INFORMATION LETTER

212-21-73

3 February 2021

SUBJECT: TAIL ROTOR BLADES 212-010-750-ALL LEAK CHECK.

Figure 1. Areas where cracks can be found.

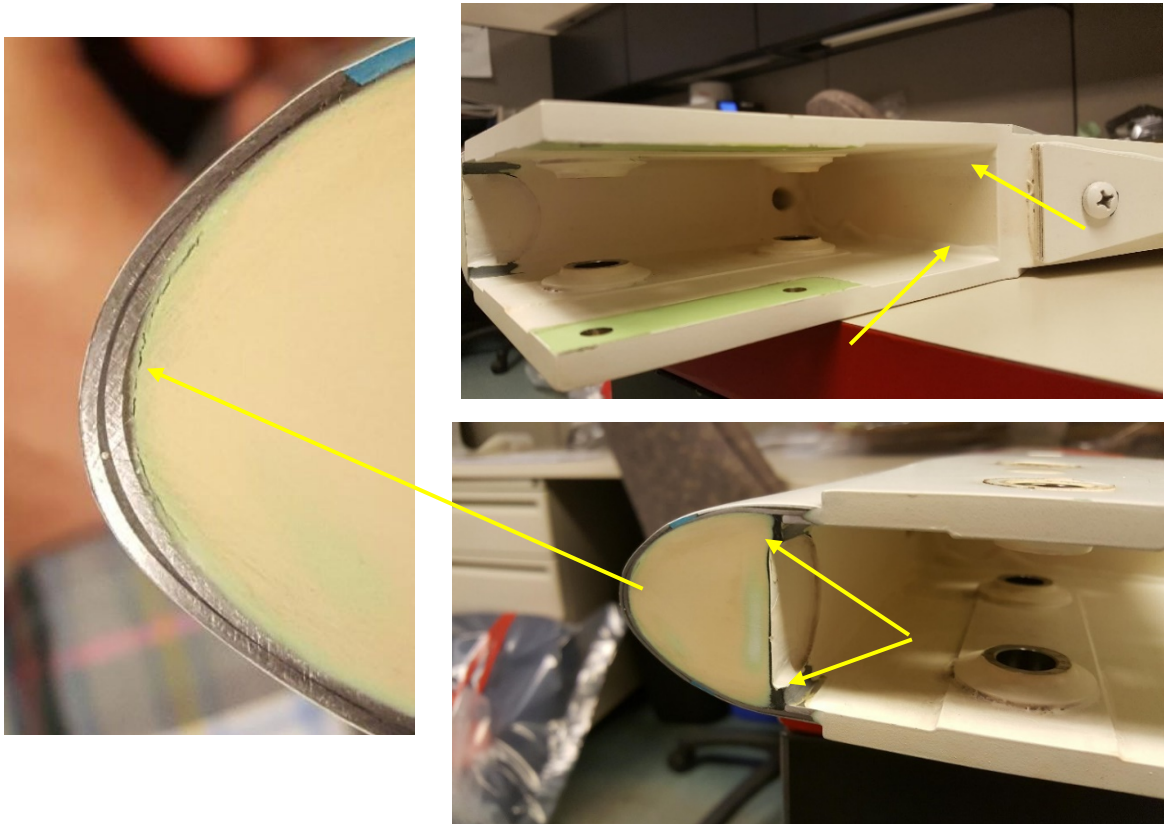
Bell has received reports of tail rotor blades failing the leak check required per the applicable Maintenance Manual (MM) when suspected cracks are found in the blade root end cuff area. In some cases, due to misinterpretation of the results, blades rejected due to indications of air bubbles were in fact serviceable. Figure 1 below shows some areas where cracks can be found. The cracks found in the root end cuff area are usually limited to the adhesive squeeze-out produced during manufacturing and are not necessarily an indication of a bonded joint failure.

Prior to the recent revision, the MM stated to look for a “steady stream” of bubbles originating from a single point when the blade is submerged in water. To avoid misinterpretation of the acceptance/rejection criteria published in the MM, the inspection criteria has been changed as follows:

The crack repair procedure found in the applicable MM and Component Repair and Overhaul Manual (CR&O), has also been changed. The adhesives (C-363) and (C-313) listed in the MM and the CR&O to repair cracks in the root end area are replaced by sealant (C-308). The flexibility of sealant (C-308) will allow the fine cracks to remain sealed and prevent further cracking with time in service.

“Check for air leaks indicated by fine air bubbles originating from a single point at a rate exceeding one every five seconds. Occasional air bubbles is not a rejection criteria. If any confusion exists, or a clarification is desired, contact Product Support Engineering.”
